**Re: Partially Recirculated Draft Environmental Impact Report /
Supplemental Draft Environmental Impact Statement
(RDEIR/SDEIS) for the Bay Delta Conservation Plan/WaterFix**

Comments on the July 2015

Bay Delta Conservation Plan / California WaterFix

Partially Recirculated Draft Environmental Impact Report /
Supplemental Draft Environmental Impact Statement

Figure 3-2. Old and Middle River flow when HORB is closed

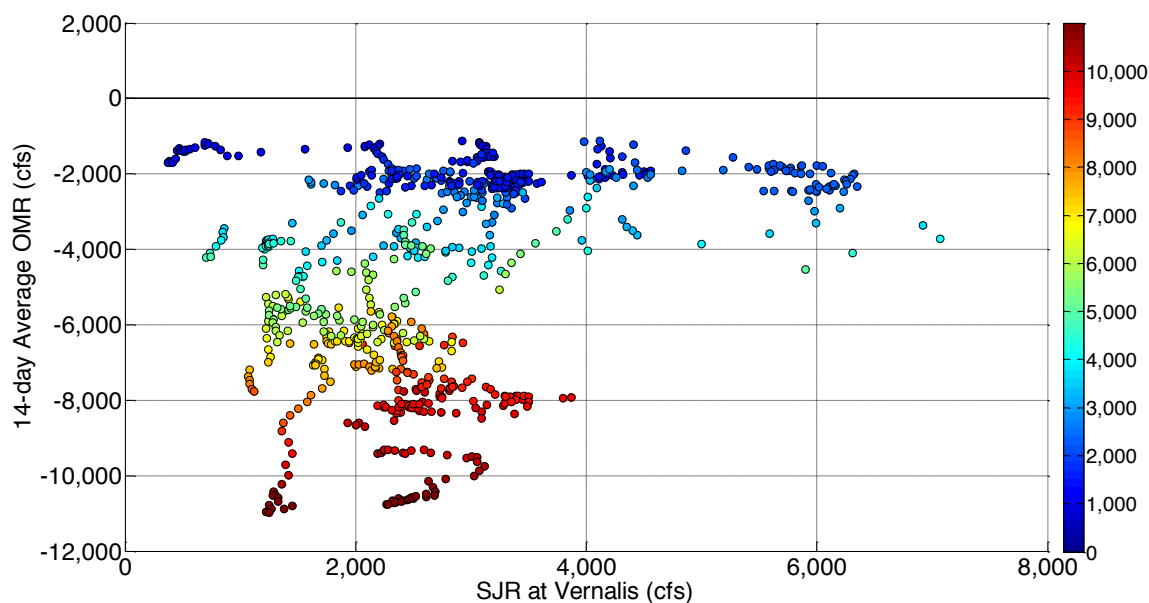
This inconsistency is demonstrated by reviewing measurements of OMR flows at times when a barrier has been installed at the head of Old River in the past. Historically, a temporary barrier of rocks at the head of Old River has been constructed in the fall or spring¹. Review of OMR flows that were measured when the HORB was installed confirms that OMR is never positive with the HORB installed (Figure 3-2).

Historical measurements of 14-day averaged tidally filtered net flow in Old and Middle Rivers when the HORB is installed plotted against the flow in the San Joaquin River at Vernalis and colored by the total pumping at the existing south Delta export facilities.

Pumping at the existing CVP and SWP export facilities in the south Delta (Jones and Banks, respectively) contributes to negative OMR – the greater the total pumping at the existing south Delta facilities, the more negative OMR (Figure 3-2). Limiting pumping at the south Delta facilities limits the negative OMR but cannot create positive OMR. Positive OMR can only occur with inflow from the San Joaquin River when the HORB is *not* installed.

Figure 3-3. Frequency of Excess Outflow in October

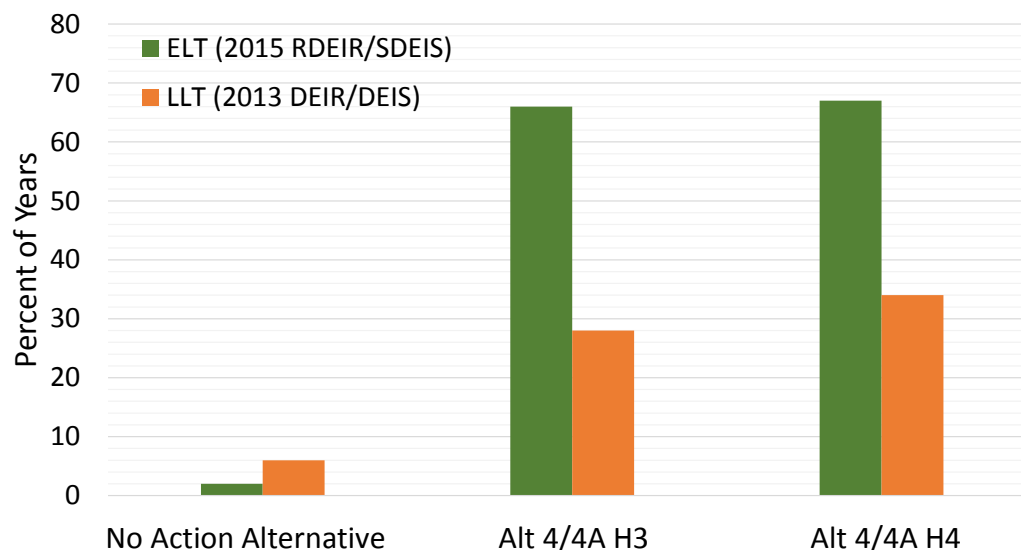
However, the BDCP modeling indicates that Delta outflow would exceed the amount necessary to meet minimum outflow requirements and salinity standards over 66% of the time in the early long term (ELT) for Alternatives 4/4A² H3 and H4 (Figure 3-3). In comparison, the No Action Alternative³ has excess Delta outflow in October only 2% of the time in the ELT.

The dramatic increase in the occurrence of excess flow under Alternatives 4/4A H3 and H4 in the ELT is not as substantial in the late long term (LLT) and is probably the cause for the different impact determinations between the ELT (as analyzed in the RDEIR/SDEIS) and the LLT (as analyzed in the 2013 BDCP Draft EIR/EIS). Although excess October Delta outflow occurs less often in the Alternative 4/4A LLT modeling than in the Alternative 4/4A ELT modeling, the frequency of occurrence in the LLT modeling is also unrealistic.

Percent of years in the 82-year analysis period (water years 1921-2003) when Delta outflow in the month of October is in excess of the amount needed to satisfy minimum Delta outflow requirements and Delta salinity standards.

Figure 3-5. Excess Delta Outflow in the month of October during the Early Long Term biases the modeling results for multiple months

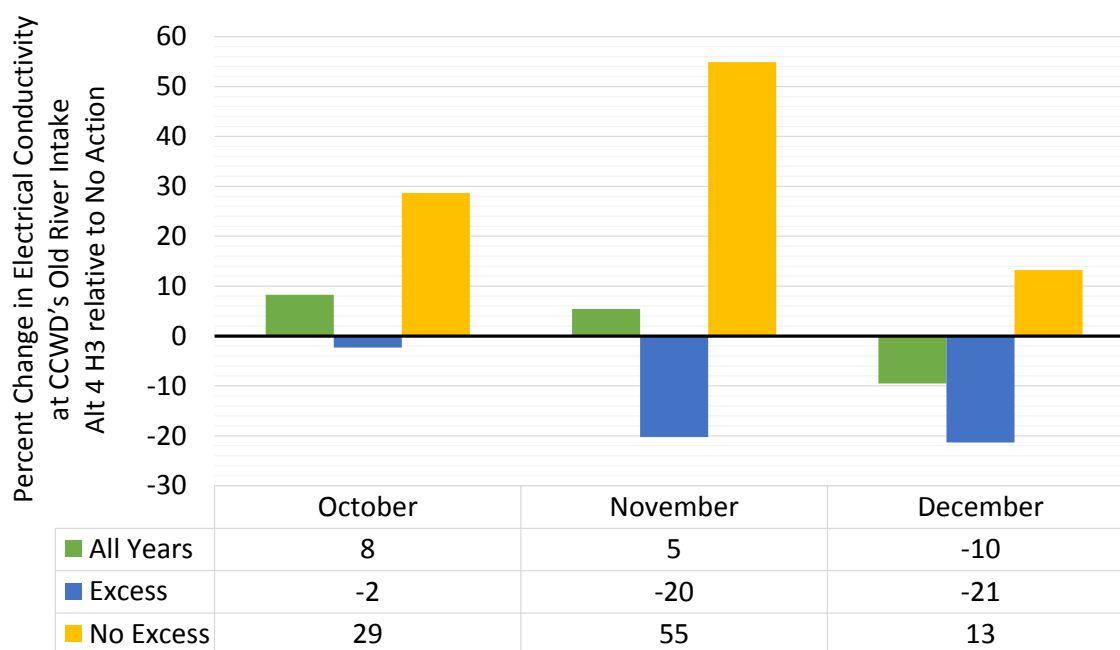
The unrealistic excess Delta outflow in October freshens the modeled interior Delta salinity for many months. This is illustrated in Figure 3-5, which shows that excess Delta outflow in October freshens the water at CCWD’s Old River Intake in October and that the freshening effect is maintained through December (blue bars in Figure 3-5). In contrast, during years without excess Delta outflow in October, Alternative 4/4A H3 increases the salinity at CCWD’s Old River Intake in October, November, and December (orange bars in Figure 3-5). Further, averaging salinity over all years (green bars in Figure 3-5) underestimates the impacts that would occur.

This discussion serves to show that the unrealistic assumption of excess Delta outflow results in a significant underestimation of salinity impacts as a result of the proposed project. Conversely, implementing and modeling an operations plan that corrects this unrealistic excess Delta outflow assumption would reveal greater salinity impacts due to the project.

Monthly average percent change in salinity in Alternative 4/4A at ELT relative to the No Action Alternative at ELT. Source: Modeling studies provided by DWR (DWR, 2013) processed for the entire 82-year study period.

Figure 5-2. Monthly Average Salinity at Collinsville both with and without operation of the SMSCG

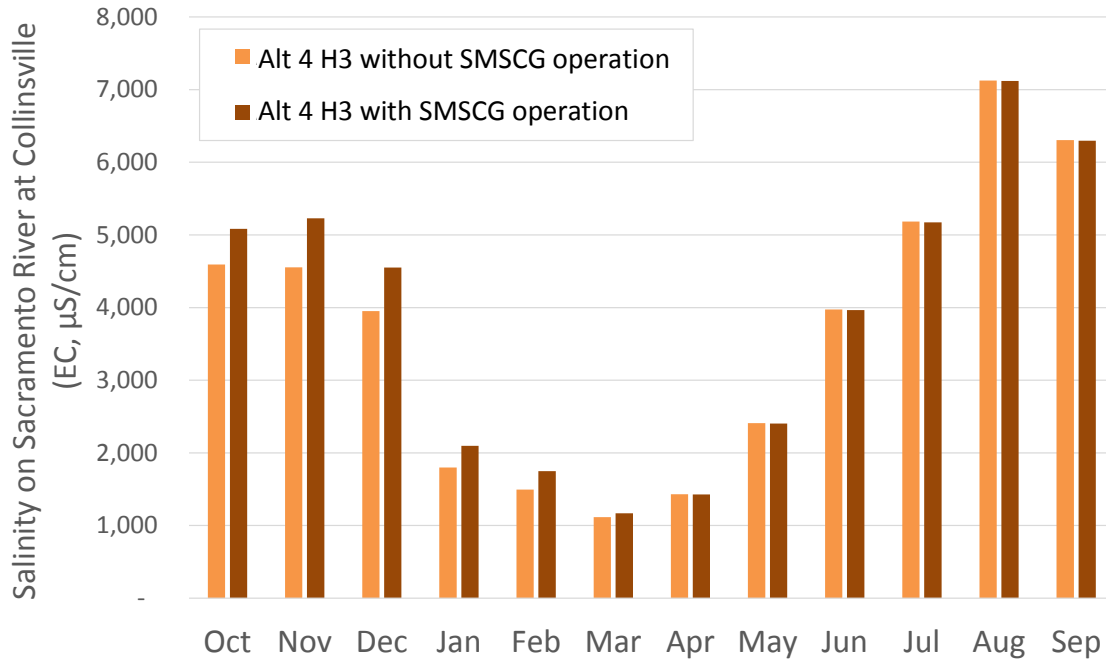
The project description for the revised Alternative 4 and the new alternatives includes operations of the Suisun Marsh Salinity Control Gates (SMSCG). However, the modeling that is used as the basis for the impacts analysis assumes no operation of the SMSCG. The RDEIR/SDEIS presents limited results from a sensitivity study that was designed to determine how operation of the SMSCG would alter Delta salinity. The study found that SMSCG operation freshens Suisun Marsh. However, the RDEIR/SDEIS does not disclose the effects that SMSCG operation would have outside of Suisun Marsh, in Suisun Bay and the Delta. The results of the sensitivity studies provided by DWR indicate that operating the SMSCG as proposed for the new alternatives is likely to create water quality impacts by increasing salinity throughout the Delta from October through March.

Operation of the gates creates a net flow of fresh water from the Sacramento River near Collinsville into Suisun Marsh equivalent to about 2,800 cubic feet per second (cfs), thus reducing salinity within Suisun Marsh (Enright, 2008, slide 40). The RDEIR/SDEIS contains graphs showing the reduction in salinity within Suisun Marsh in response to operation of the gates. RDEIR/SDEIS, Appendix A, Appendix 8H, Attachment 1 at p. 10 (Figures 9 and 4).

However, diversions of the freshwater into Suisun Marsh via operation of SMSCG *increase* salinity in Suisun Bay and the western Delta (Enright, 2008, slides 43 and 44). The RDEIR/SDEIS does not disclose the degradation in water quality that SMSCG operation would have within Suisun Bay or the Delta. Figure 5-2 below shows changes in salinity in the western Delta at Collinsville that are caused by SMSCG operations. The increase in salinity from October through March is an effect of project operations that is not captured by the outdated modeling that was used to evaluate water quality impacts.

Figure 5-3. HORB affects water quality in the south and central Delta

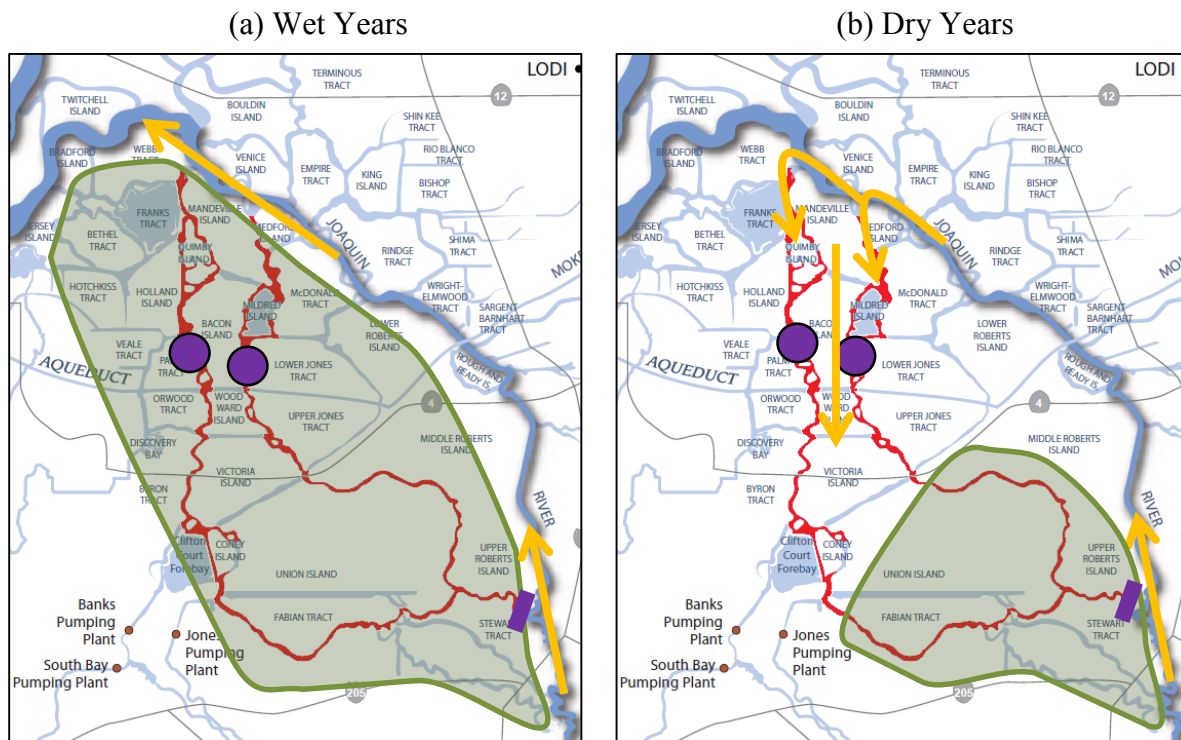
Closure of the HORB impacts the water quality in the south and central Delta; Figure 5-3 shows the geographical extent of the impacts in wet and dry years.

During dry years, the project as described in the RDEIR/SDEIS allows OMR to be negative while the HORB is closed. With no flow entering Old River from the San Joaquin River at the HORB, and with the export pumps operating, the San Joaquin River would flow north past the HORB, then turn south entering Old and Middle Rivers from the north and creating negative OMR (Figure 5-3(b)). The central Delta would receive this water heading from the north, and thus would receive a greater proportion of San Joaquin River water as compared to baseline conditions. This is an important consideration for water quality in the central Delta, since during dry years, San Joaquin River flows are generally low and the water quality is poor. Further, with the HORB closed, stagnant conditions would be created in the south Delta.

For both wet and dry years, impacts would be greater than what is modeled. In the stagnant regions, flow in the channels would oscillate with the tides, but without net flow, the residence time would be very long. (Residence time is estimated by the volume of water in a region divided by the net flow through the region, so as the net flow approaches zero, the residence time approaches infinity.) Long residence times provide optimal conditions for harmful algal blooms as discussed in Section 2.2.1.2 of CCWD's July 25, 2014 comment letter on the 2013 BDCP Draft EIR/EIS.

Closure of the HORB prevents the San Joaquin River from entering Old River in the south Delta, creating a stagnant region to the west of the HORB (green shading). The extent of the stagnant region is dependent on the OMR regulations. In relatively wet years (a), the project description often requires OMR to be positive, preventing any flow from the north from entering the region and expanding the stagnant zone throughout the south and central Delta southwest of the San Joaquin River. In relatively dry years (b), the project description allows OMR to be negative, allowing CVP and SWP pumping in the south Delta and causing the San Joaquin River to turn south and enter Old and Middle Rivers from the north.

Figure 5-4. HORB affects water quality in the south and central Delta, sensitivity study results

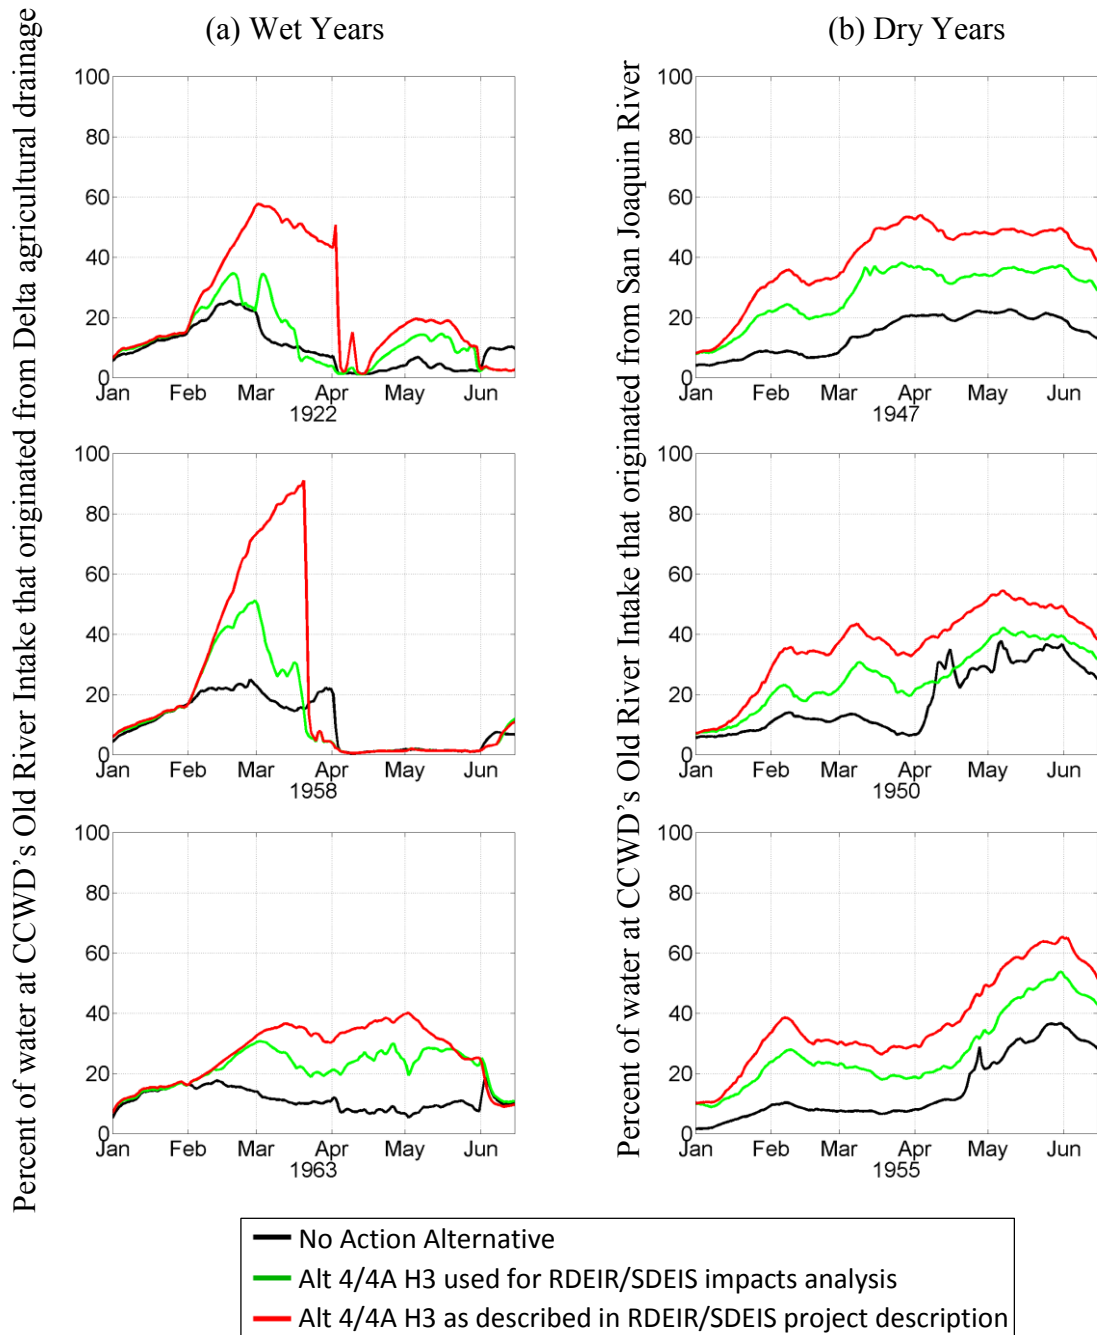
CCWD conducted a sensitivity study to evaluate the degree to which the analysis in the RDEIR/SDEIS underestimates the impacts of the new alternatives. Unlike the modeling used for the impact analysis in the RDEIR/SDEIS, CCWD’s sensitivity study assumes that the HORB is closed when the project description indicates it should be closed. The CCWD study also reduced south Delta exports if necessary to attempt to meet the OMR requirement. Note that because no parameters are indicated in the project description to open the HORB for water quality or water stage concerns, this was not simulated in the CCWD study. Figure 5-4 illustrates the results for three wet years (Figure 5-4(a)) and three dry years (Figure 5-4(b)). In all six years, the negative water quality effects of the proposed project are greater than what is disclosed and evaluated in the RDEIR/SDEIS.

Results of CCWD’s sensitivity study (red lines) indicate that the modeling used for the RDEIR/SDEIS impacts analysis (green lines) underestimate the project’s adverse impacts on water quality relative to the baseline (black lines). In relatively wet years (a), an increase in percent of water from Delta agricultural drainage would increase salinity, nutrients, algal biomass, and pesticides at CCWD’s intakes. In relatively dry years (b), an increase in the percent of water from the San Joaquin River would increase salinity, nutrients, and pesticides at CCWD’s intakes.
